## INTERNAL MEMORANDUM

### FROM: HIGHWAYS & TRANSPORT; PLACE DIRECTORATE

**Application No: 23/P/1387/OUT**

**Proposal: Outline planning permission for the demolition of existing bungalow and proposed redevelopment of up to 9 no. residential dwellings, with access for approval ; and appearance, layout, landscaping and scale for subsequent approval.**

The applicant has submitted a revised plan (1595-CAL-VI-ZZ-SK-D-0001 Rev P08) which show the visibility splays from the proposed access. The applicant is proposing 37m of visibility to the north and 31m to the south at a point 2.4 meters back from the edge of the carriageway. This is a

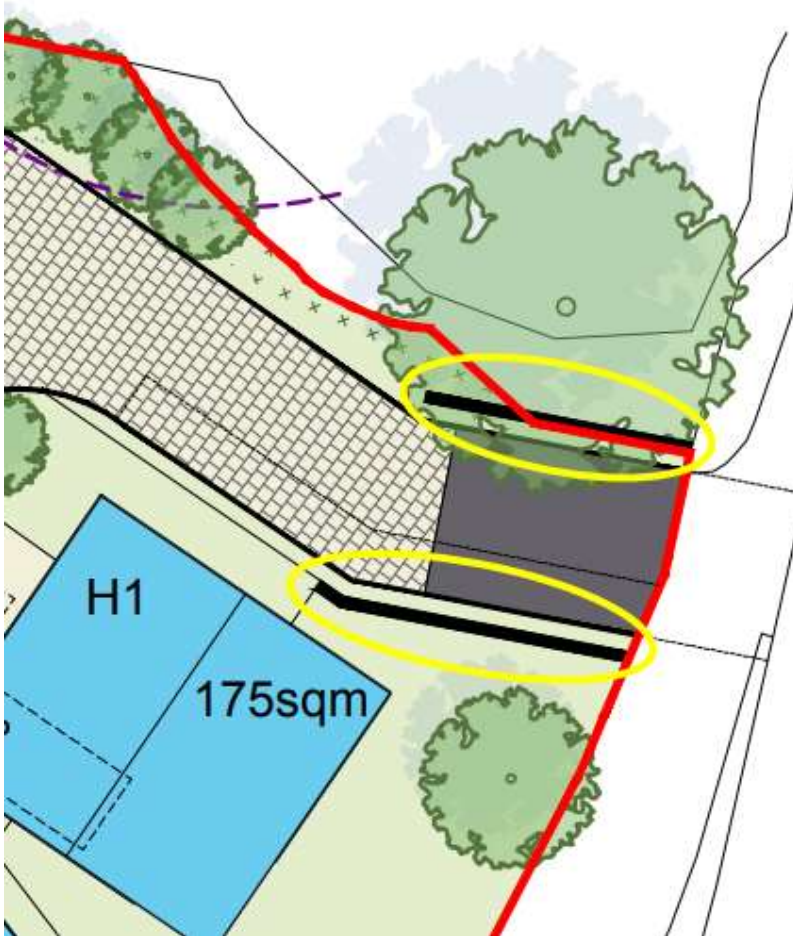
deviation to the required 43 meters required on a 30mph road. The applicant submitted speed survey data at point 3.5 of the Transport Assessment which shows 85% speeds lower than the signed limit. Due to the reduction in visibility Road Safety Officers require the BT boxes located adjacent to the access to be relocated and all vegetation within the visibility splay to be removed for the access to be considered suitable. The applicant should provide **revised plans** showing the removal/relocation of the BT boxes adjacent to the access. This is required to provide the maximum visibility that is achievable at the access. The applicant must splay the entrance to ensure maximum visibility for all users as indicated on the extract below in red and blue lines.

The 'Sketch Proposals Option 21 SK019' show two black strips adjacent to the access, **the applicant is to clarify what these are proposed to be**. There must be no obstructions to the visibility above the height of 600mm up to 2m above the carriageway and this is **to be conditioned**.
